Appealing the granting of height and number of stories waivers for Highrose/Verandas

RE: Verandas Project – Building and Ceiling Height

Staff addresses specific arguments made by the appellant below, with the italicized text taken directly from the appellant's written appeal applications.

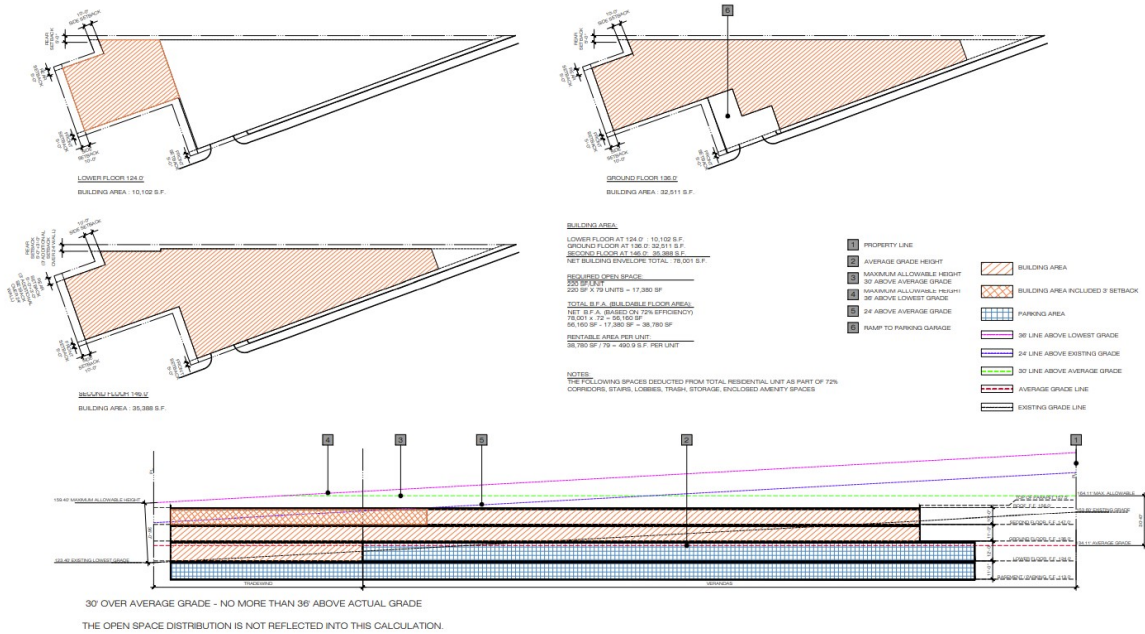
Mr. Buckley stated, at the commission appeal hearing (6/08), that they could have submitted an even taller building but out of consideration for the character of the city they went with this plan.

I urge Mr. Frank Buckley, though the state density bonus plus the city's allows you to have 79 units can you try to show some more of that love and fit what you can within the local code limits. You would still be left with 69 units with 6 affordable units that yields you 11 units more than what you would have had without the bonuses (52).

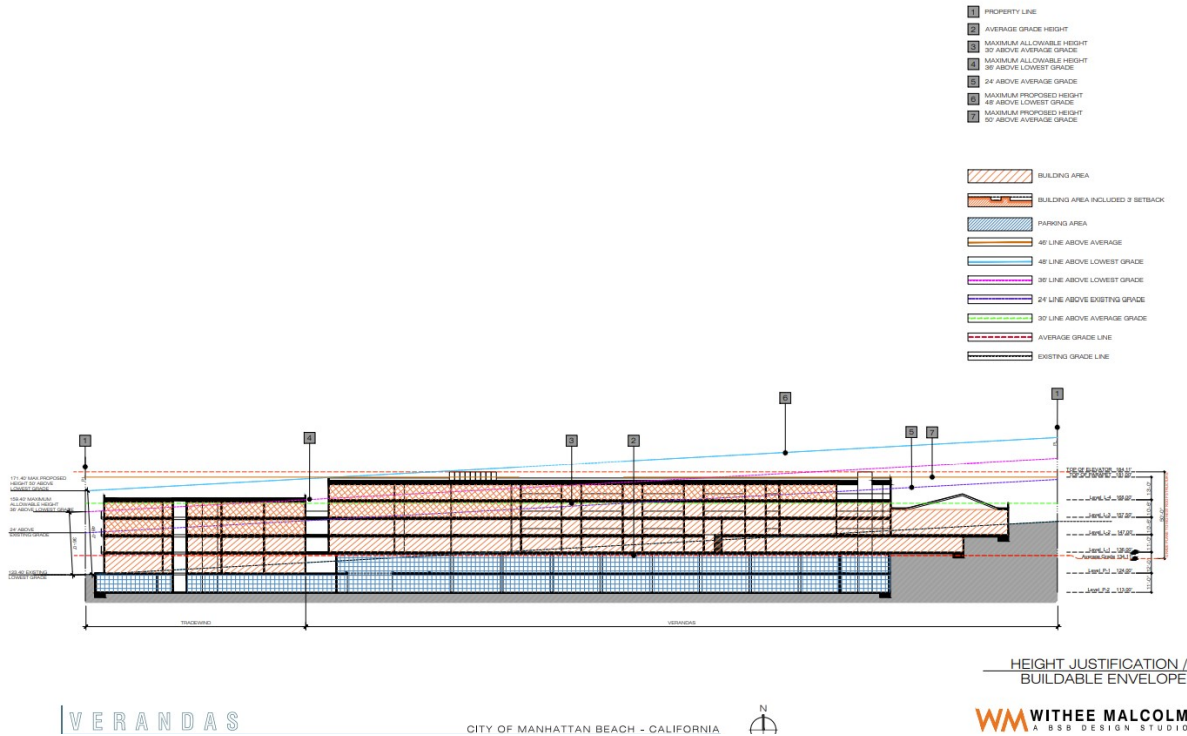
2. *They requested the waivers; does it mean we are powerless to refuse them?*

The City has building codes for a reason to protect its citizens and the character of the community. If we are to ignore the code will the next very affordable development be, 150 units 80 feet high with 15 very affordable units? What is there to stop that?

Per California Government Code Section 65915 (a)(2), State law "does not prohibit a local government from requiring an applicant to provide reasonable documentation to establish eligibility for a requested density bonus, incentives or concessions, as described in subdivision (d), waivers or reductions of development standards, as described in subdivision (e), and parking ratios, as described in subdivision (p)."

The applicant has provided documentation that establishes the project's eligibility for requesting a density bonus, concession, and waivers from development standards. This documentation includes written explanations on why waivers and concessions are

necessary (page 05-01 of the plans), a study of the buildable envelope and resulting average unit size for a project that did not request any concessions and waivers from development standards (page 05-02 of the plans), an analysis of the height limitations and how it affects the resulting structure (page 05-03), an analysis of average residential rental unit size in Manhattan Beach (Attachment K), and a letter from the project architect describing the typical ceiling heights for new residential projects, including affordable housing project (Attachment L).

All of the aforementioned documentation constitutes substantial evidence on the project's eligibility for a density bonus, concessions, and waivers from development standards.
